Menlo Commons, August 09, 2022

With this file I am asking you to explain your layout, especially the note “Door Clearance”, which I just don’t understand.

Dag’s counter-proposal interpreting and rearranging Parisa’s layout

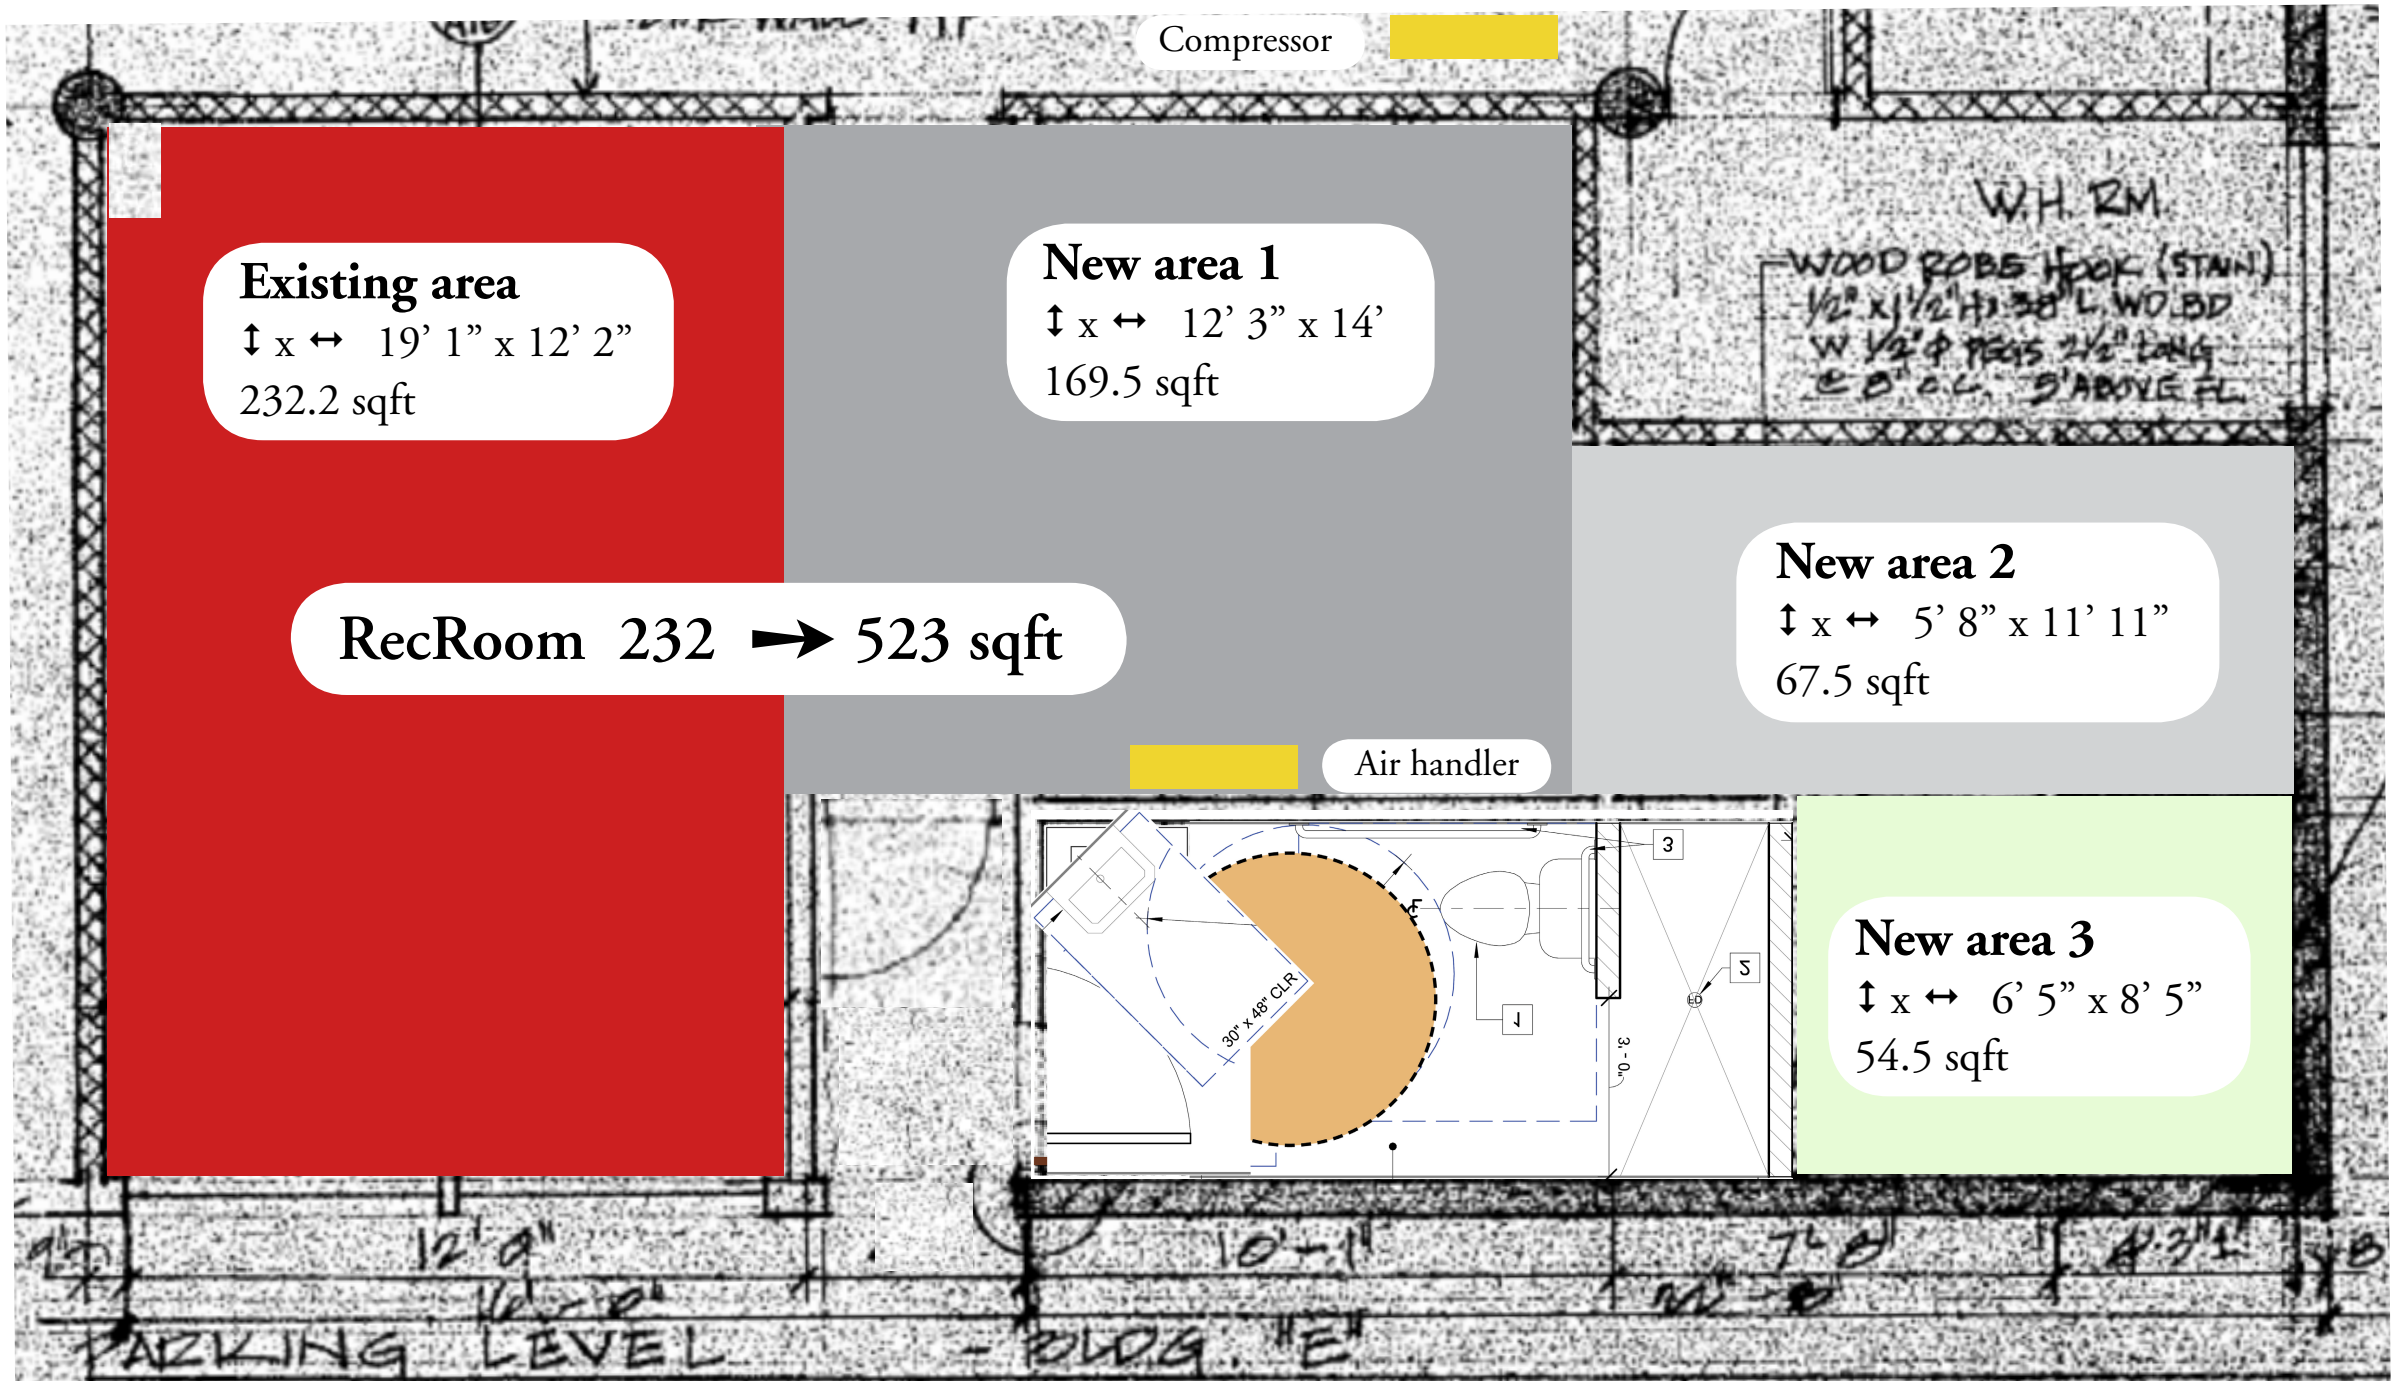
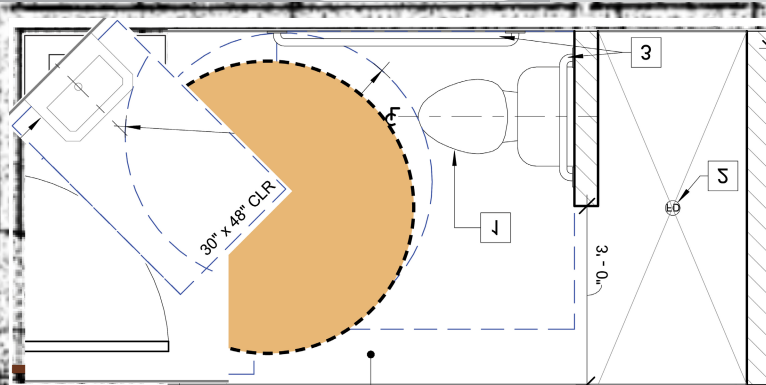
In the spirit of proposal (yours) and counterproposal (mine) I mean to engage in productive dialogue, an iterative process of explaining, understanding, sleeping on it, and finding a satisfying design. You have yet to explain your considerations, so this counter-proposal may be premature. That can’t be helped. Time is of the essence.

If this layout is feasible, it will mean not having to create a new toilet drain in the concrete floor, and a substantial increase in RecRoom space. Here is hoping ☺

RecRoom 232 → 523 sqft
